Queensland Floods Commission of Inquiry  
PO Box 1738  
Brisbane QLD 4001

**Submission to the Queensland Floods Commission of Inquiry  
regarding the future Operation of Wivenhoe Dam.**

Fig 1 above shows the recent Brisbane flood event with the discharge rate plotted as AEP. (This rate was as per the manual.)

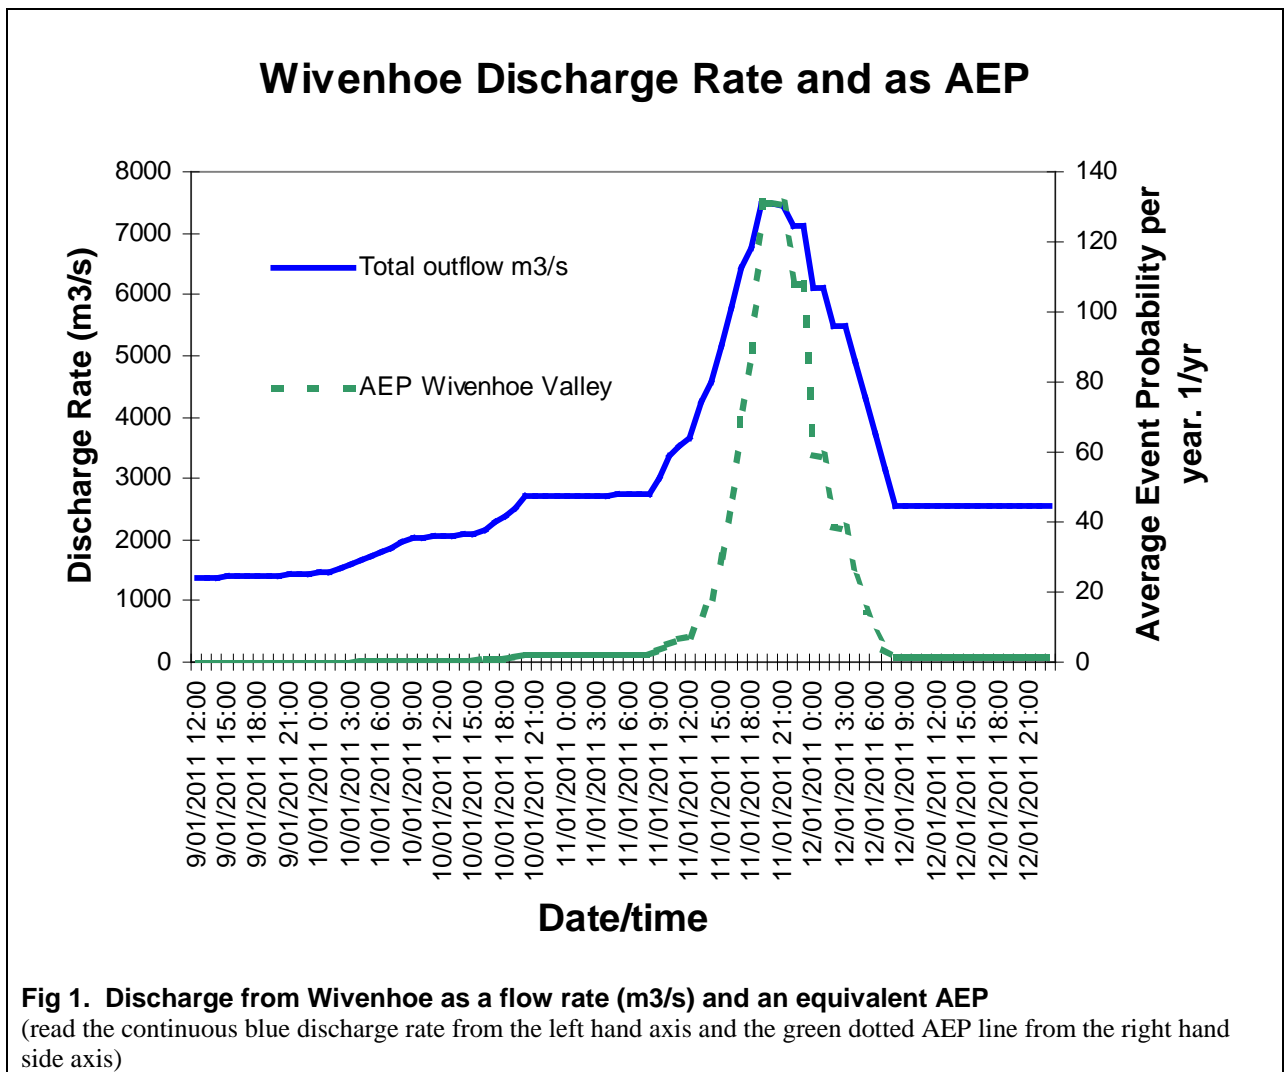
Above the 74m level (some 1.7m below the first fuse initiation level) the Operation Manual ramps up the discharge rate from a 10-year to a 500-year rate before the first fuse blows.

It indicates that the dam was discharged at a rate equivalent to the expected flow past that point (if there were no dams present) that would occur every 100 years.

I don't wish to criticise in hindsight but illustrate the events of the last flood by the use of the AEP values. At 11:00 on 11/1/11 the controllers had increased the discharge to around the 10-year AEP rate as per the Operation Manual (discharge rate is related to dam height). If this discharge rate had been held from this point in time till the fuse level, the dam would not have reached the first fuse plug level and the flood in Brisbane would have been significantly lower due to the maximum discharge being around half of the actual. ie a 10-year flood just below Wivenhoe vs a 100-year flood.

To continue to illustrate this extreme situation - should the rain have continued to fall at the 2000 yr AEP rate indefinitely (or the maximum inflow to the dam at 11:00 on 11/1/11) the operators would have continued to increase the discharge rate (as per the Operation Manual) and the dam level would have blown the first plug level then the dam level decreased slightly and stabilised. The second fuse would not have blown.

So the dam was not in danger even if this extremely high inflow rate persisted forever.

Brisbane would obviously have been flooded at a 2000-year level if the rain continued at the 2000-year level indefinitely but the point is that the dam would not have been in danger. The only thing in danger from such an extreme event, was a fuse plug, which is designed to be sacrificial in extreme circumstances.

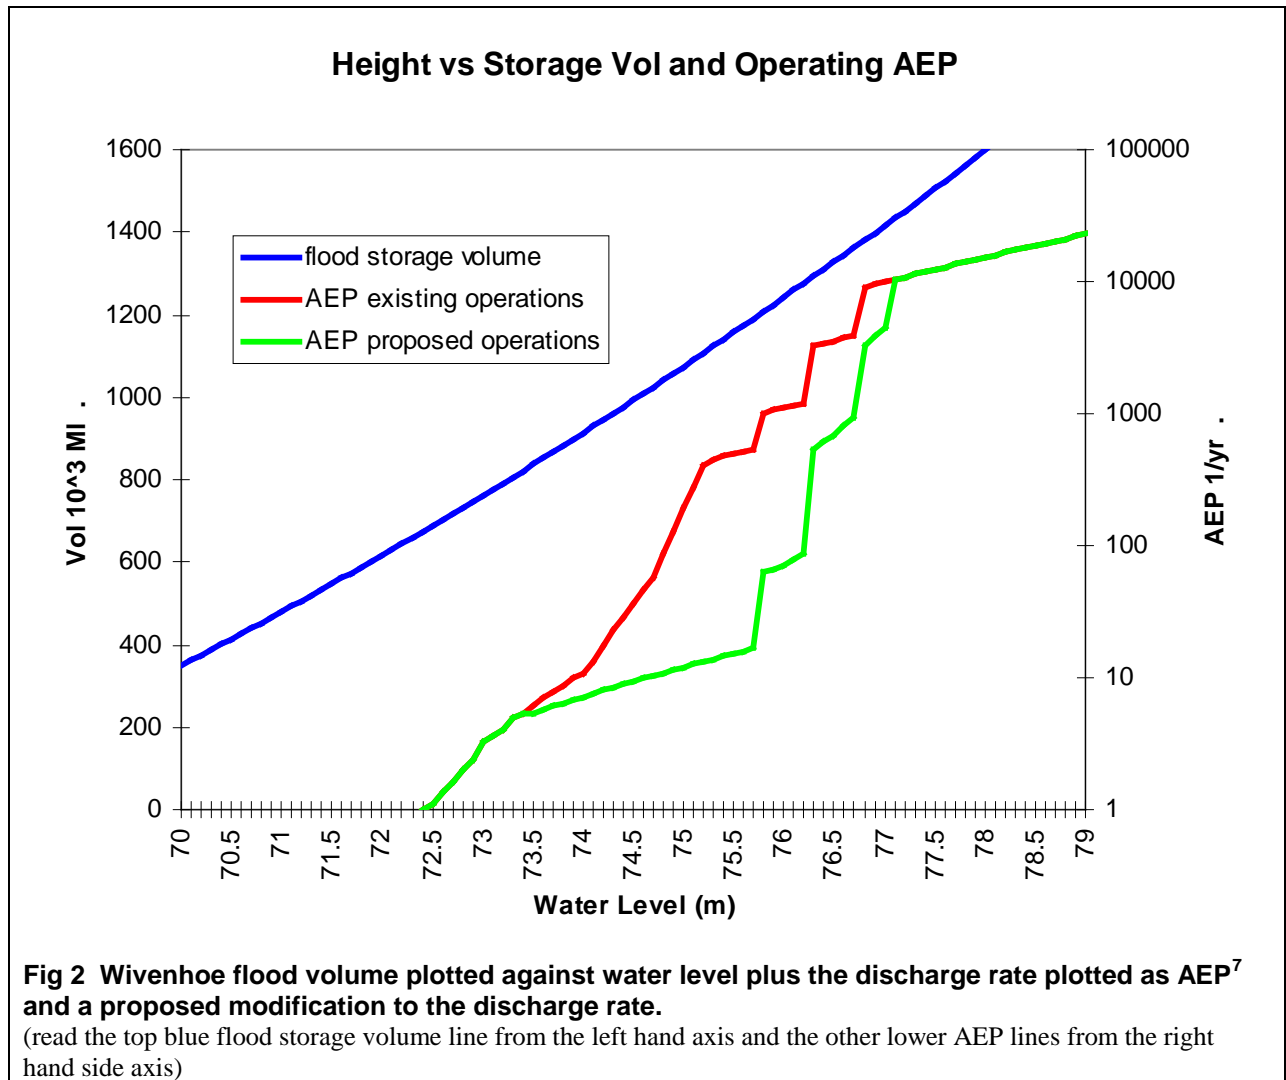
The Operation Manual discharge rates (release gate heights) for a given dam height can easily be modified to produce a more 'user friendly' downstream flood whilst utilising the existing dam capacity and without increasing the risk to the dam.

Fig 2 below shows how by restricting the flow till the dam level is higher gives an effective 25% increase in the capacity of Wivenhoe dam for 'no cost'. This brings the dam operation closer in line with its original intent. It also does not change the risk to the dam (although increases the risk to the fuses!)

The note above shows how if this procedure had been in operation in January the flood event would have been significantly reduced.
